# RUSSIAN MARITIME REGISTER OF SHIPPING

**CIRCULAR LETTER**

**No. 314-42-1382c**

amendments to the Rules for the Classification and Construction of Sea-Going Ships, 2020, ND No. 2-020101-124-E

Fig. 3.3.2.5.10

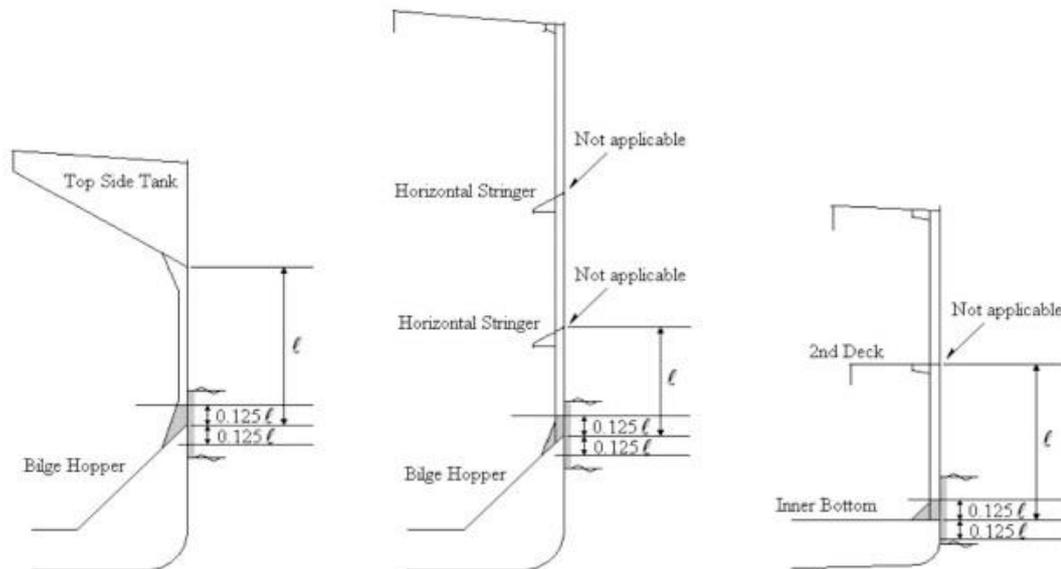
"For bulk carriers of 150 m in length and upwards with single side structures, carrying solid bulk cargoes having a density of  $1,000 \text{ kg/m}^3$  and above, the material grade shall not be less than grade D/DH for lower bracket of side frame (refer to Fig. 3.3.2.5.10);".

"**3.3.2.5.10** For bulk carriers of 150 m in length and upwards with single side structures, carrying solid bulk cargoes having a density of  $1,000 \text{ kg/m}^3$  and above, the side shell plate between two points located to  $0,125l$  above and  $0,125l$  below the intersection of side shell and bilge hopper sloping plating or inner bottom plate shall be made of steel not less than grade D/DH, where  $l$  is the span of the side frame defined as the distance between the supporting structures, in m. In case of side frames built with multiple spans, the above requirements apply to the lower part only (refer to Fig. 3.3.2.5.10).
